**REVISED**  
**07.08.2015**

west

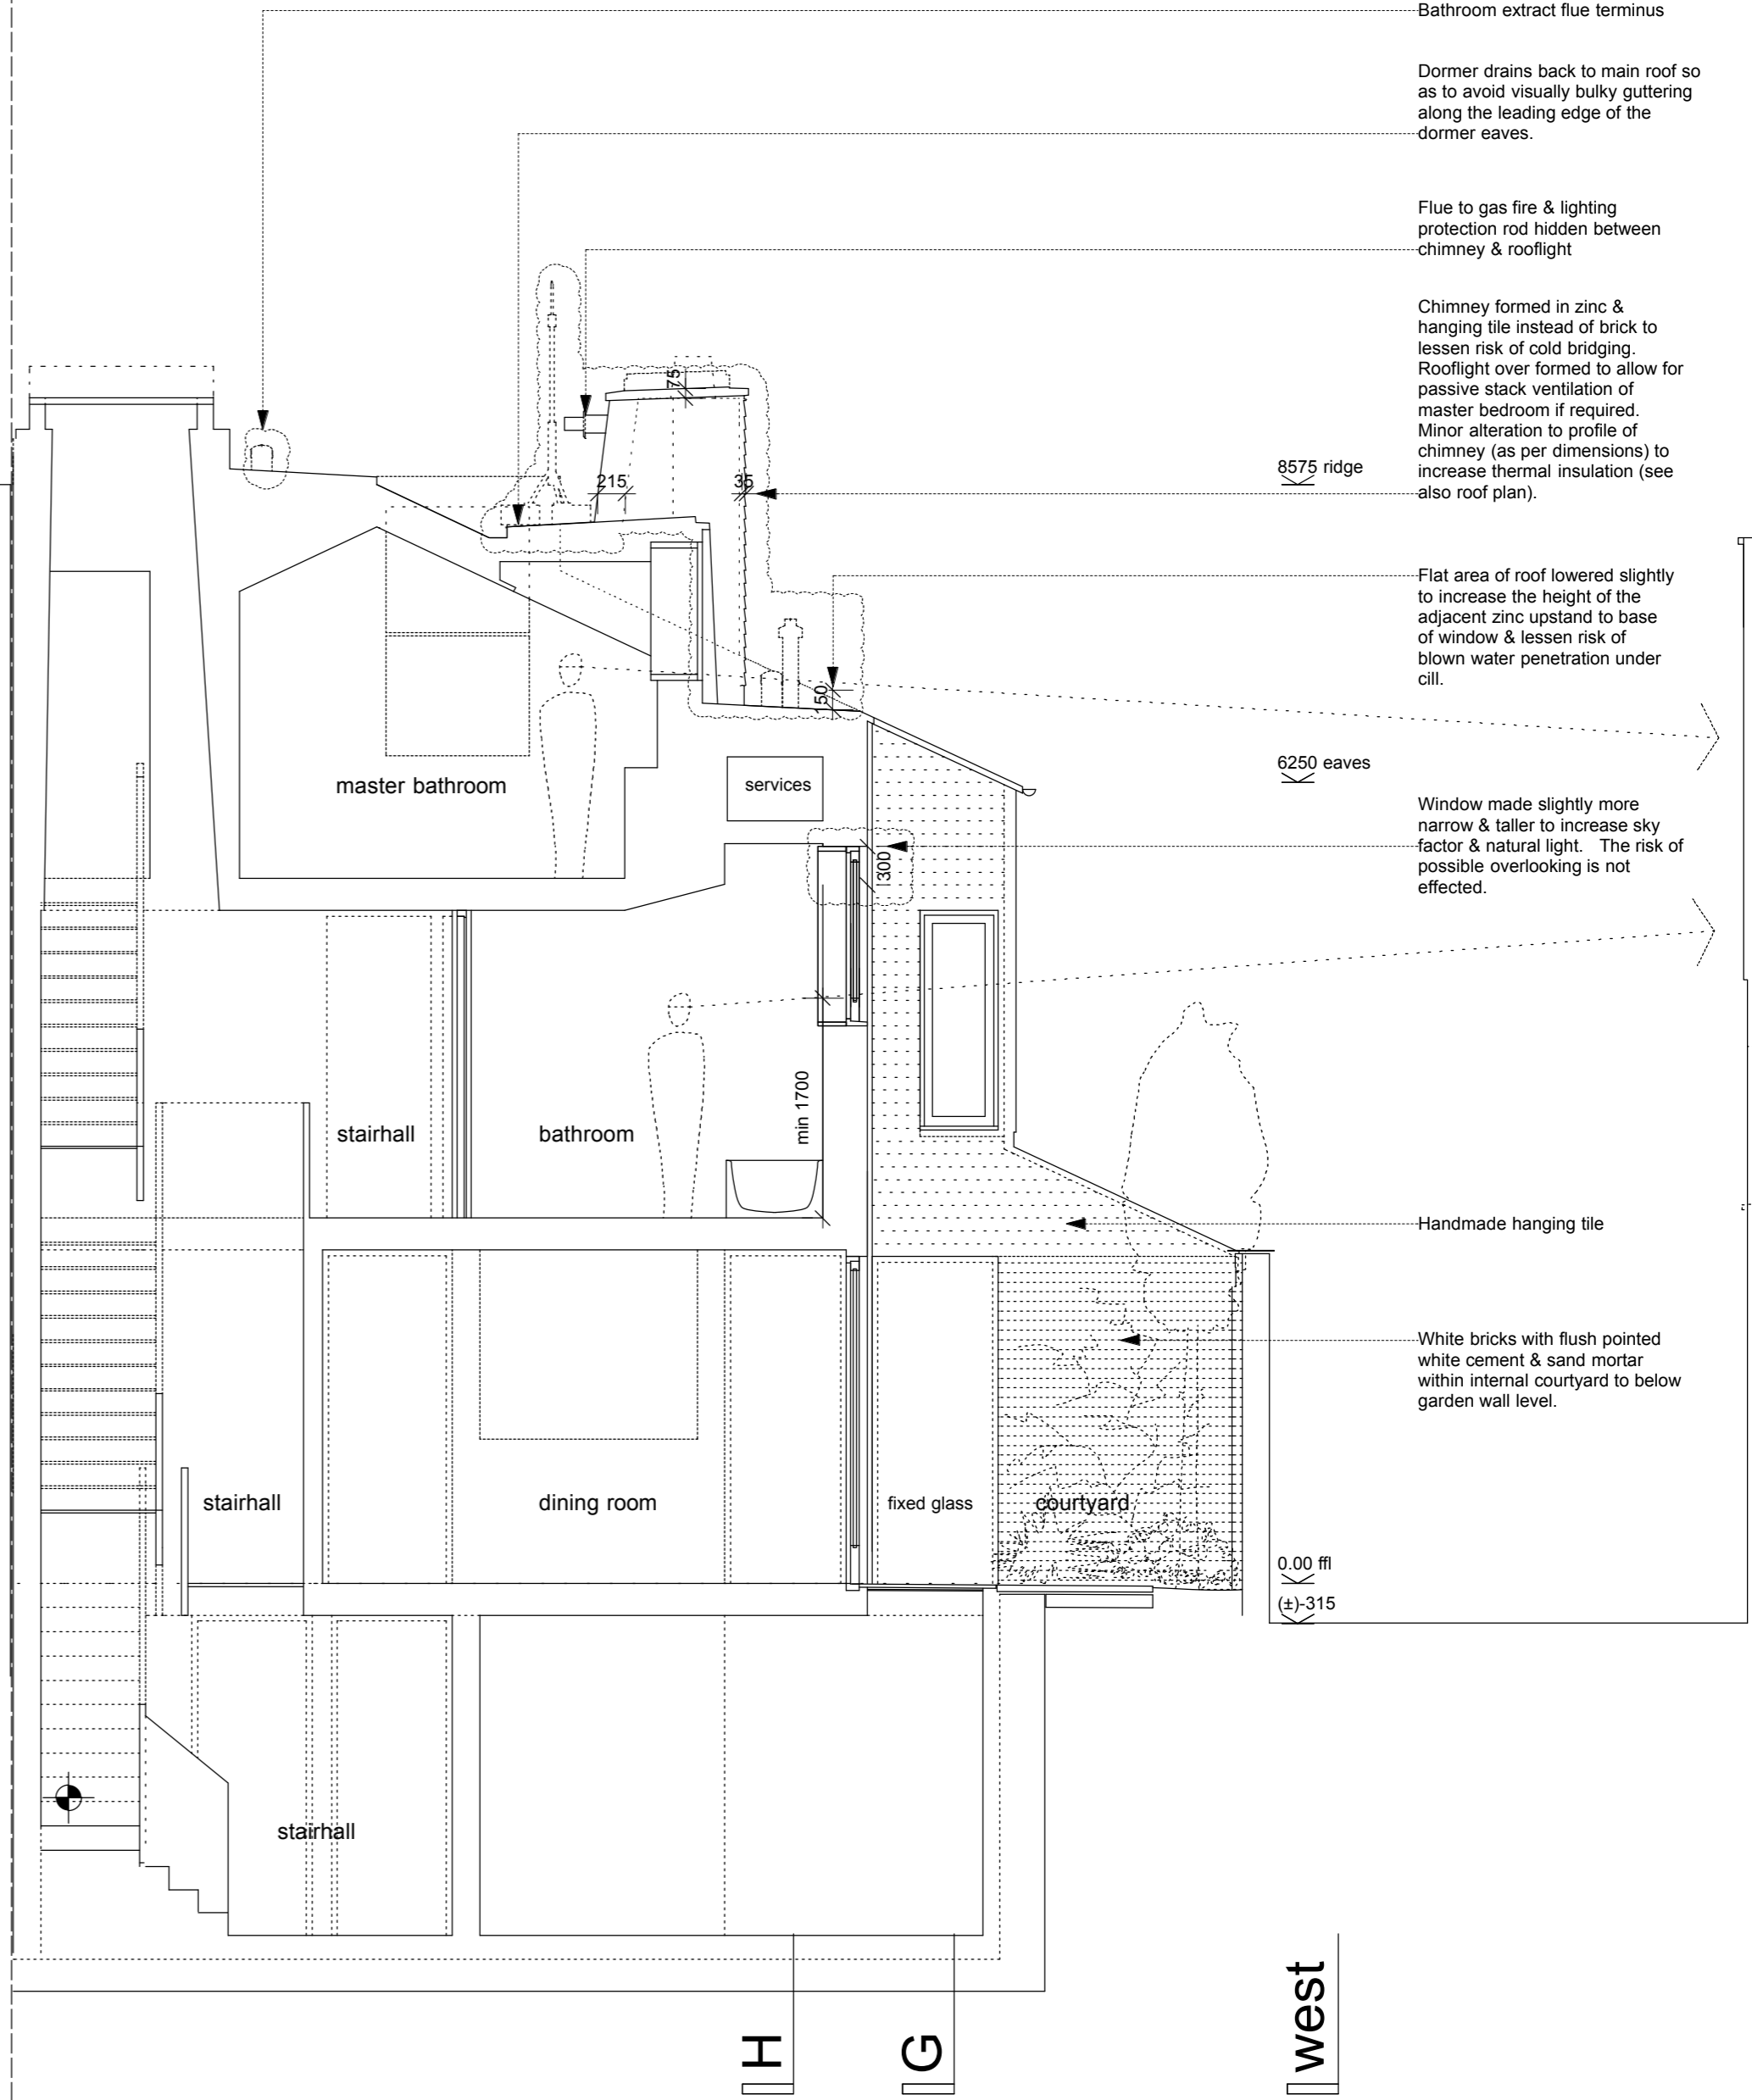
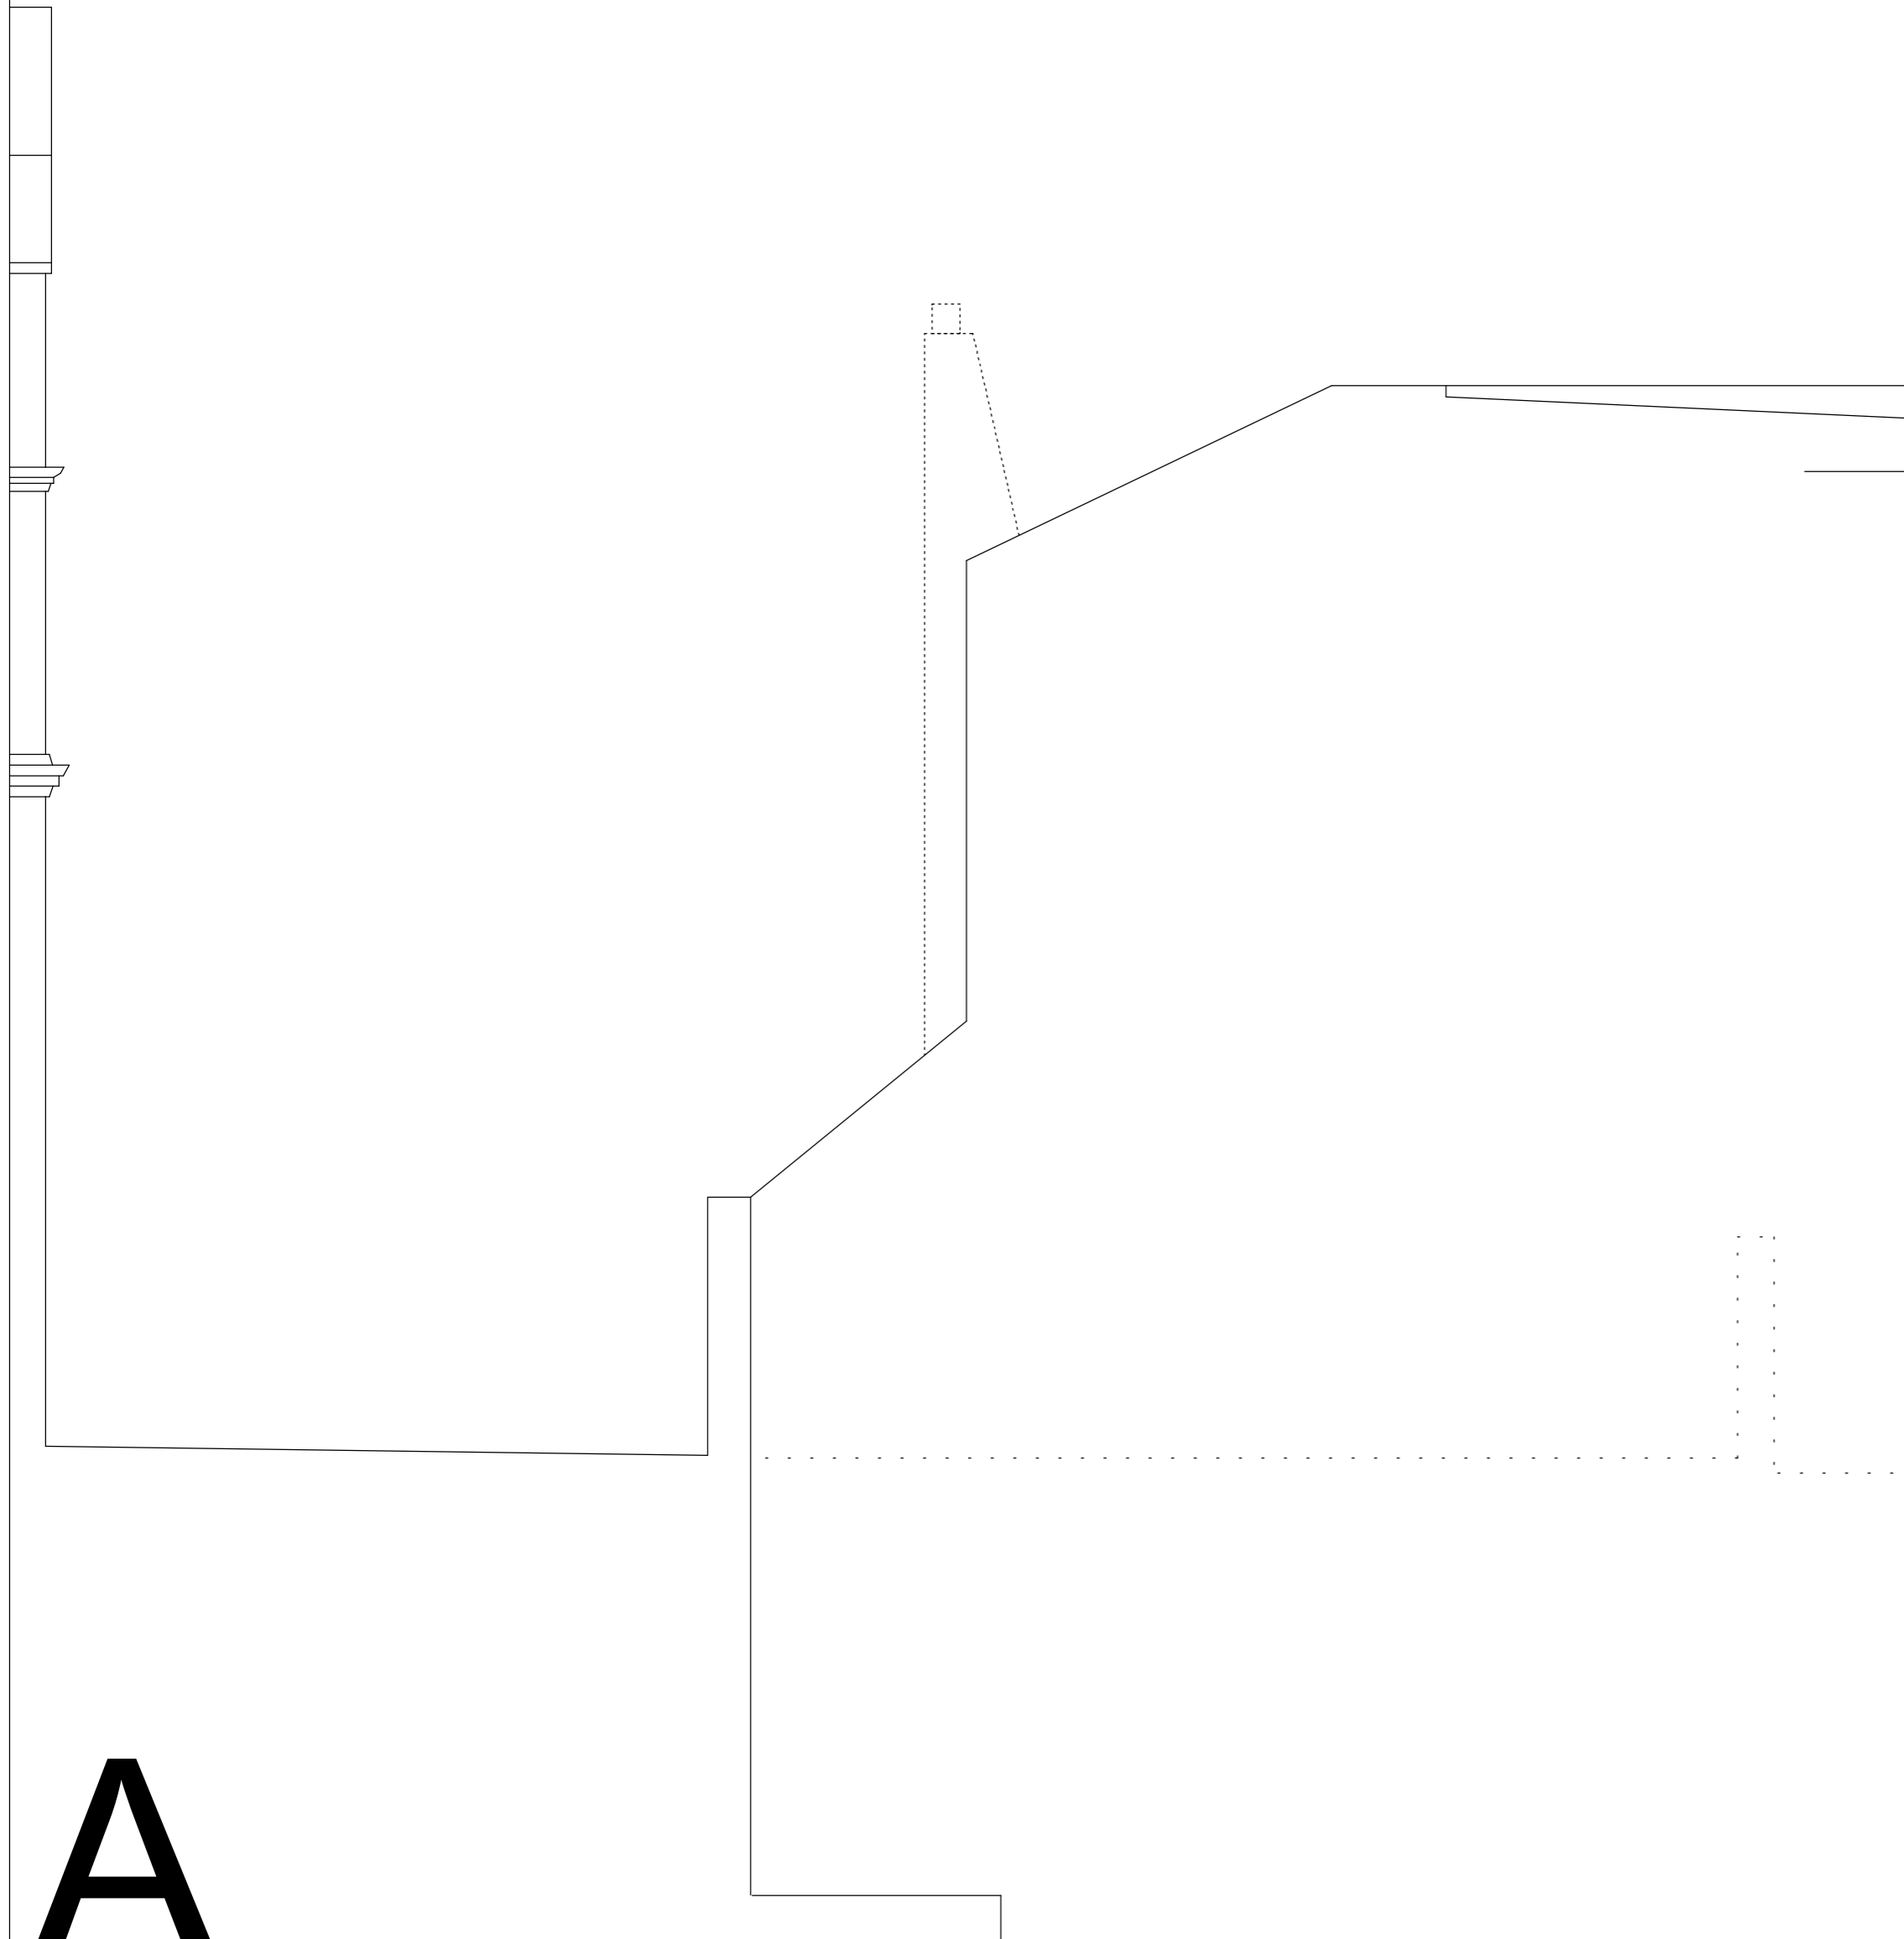
Dormer drains back to main roof so as to avoid visually bulky guttering along the leading edge of the dormer eaves.

Chimney formed in zinc & hanging tile instead of brick to lessen risk of cold bridging. Rooflight over formed to allow for passive stack ventilation of master bedroom if required. Minor alteration to profile of chimney (as per dimensions) to increase thermal insulation (see also roof plan).

Flat area of roof lowered slightly to increase the height of the adjacent zinc upstand to base of window & lessen risk of blown water penetration under cill.

Window made slightly more narrow & taller to increase sky factor & natural light. The risk of possible overlooking is not effected.
